Vale of Glamorgan Council

2024/00306/FUL – Land South of Hood Road, Barry

Transport Assessment Review

Client	Vale of Glamorgan Council
Project Name	Land South of Hood Road, Barry
Document Title	Transport Assessment Review
Document Reference	LTP/2418/TAR/01

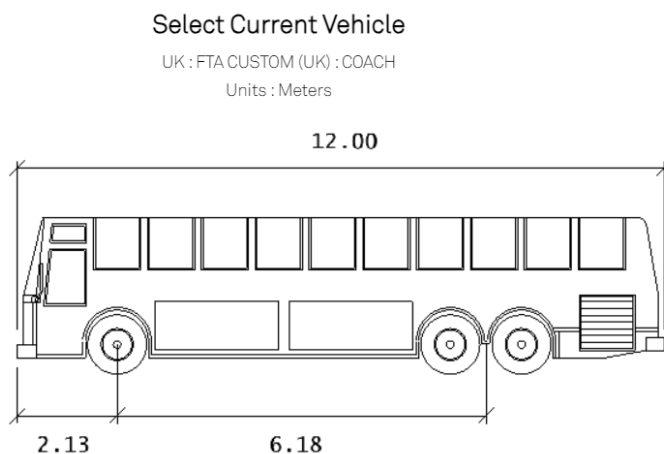
The TA states that there is insufficient room within the internal layout to accommodate a 15-meter coach. The TA does not indicate how many coach movements would be expected or whether a more modest 12-meter coach, such as a typical FTA vehicle, could access the site, as shown below.

5. Additional swept path analysis to be provided, to include HGVs and a 12.0m coach. VOGC to confirm the required refuse collection vehicle size.
6. A Delivery Management Plan should be provided for VOGC approval, and the maximum size of each vehicle category that can access the site and which manoeuvres are feasible should be stipulated.
